PSI DWG # V049-8-541  
L100-D961657-B-V

ITEM	QTY.	PART NO.	DESCRIPTION
PART LIST			MATERIAL SPECIFICATION: T304
UNLESS OTHERWISE SPECIFIED DIMENSIONS ARE IN INCHES TOLERANCES ARE: DECIMALS ANGLES FINISH .XX ± .01 ± 1°0' 32/ .XXX ± .005		CONTRACT OR SALES ORDER NO.	
UNSPECIFIED FILLETS: R.015 BREAK EDGES .010 ± .45° REMOVE ALL BURRS		APPROVALS	
THIRD ANGLE PROJECTION		DRAFTER	DATE
DO NOT SCALE DRAWING		CHECKER	ENGINEER
CADD FILE NAME		TITLE	
B103457B		RING TYPE STIFF. ROLL-UP MACHINED	
USED ON		DWG. NO. 103457	
D103225		SCALE: NONE	
		SHEET 1 OF 1

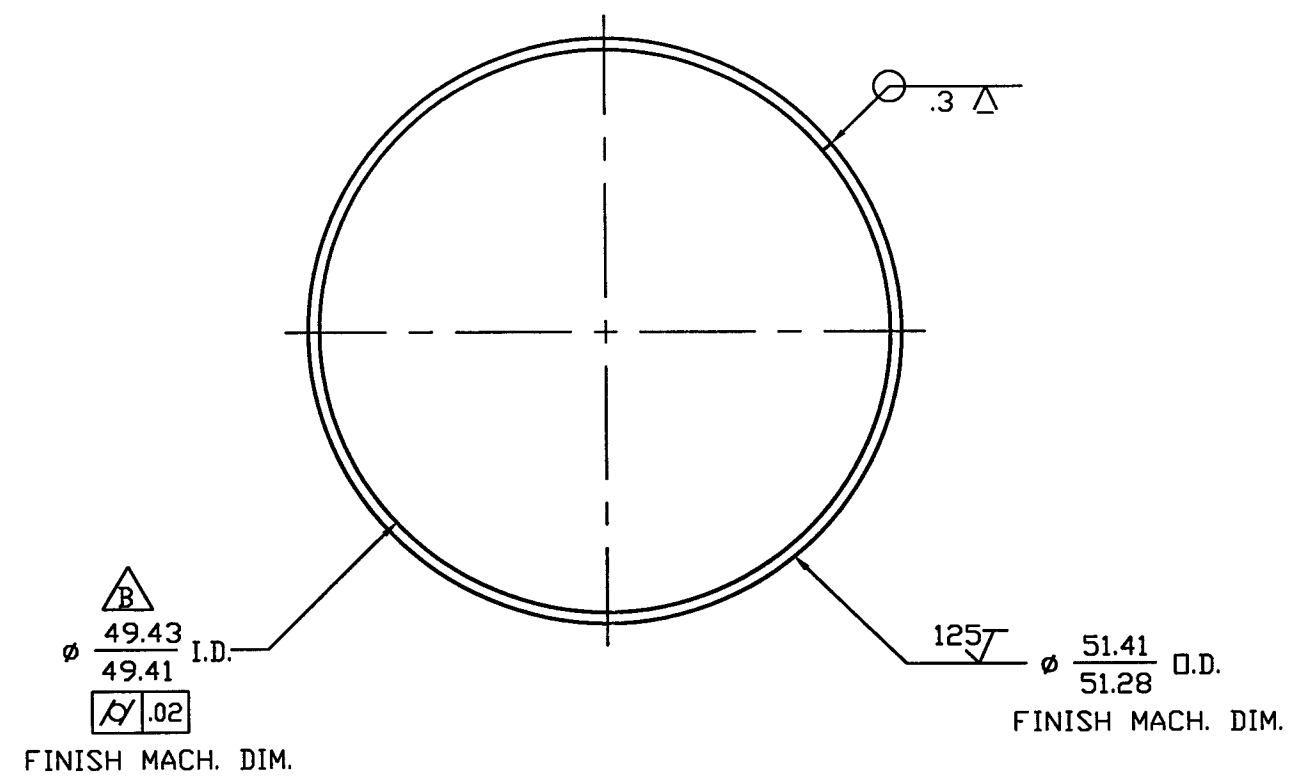
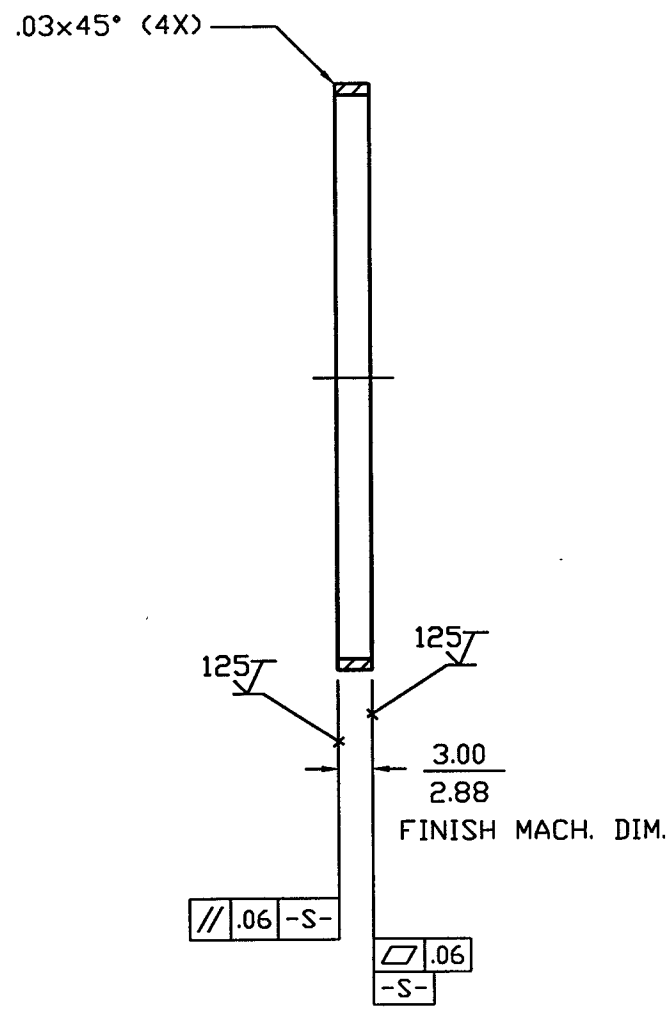
REVISIONS			
REV.	DESCRIPTION	APPROVED	DATE
A	RELEASED	AJL	10/17/96
B	Ø49.43/49.41 WAS Ø49.41/49.39	AJL	10-20-96
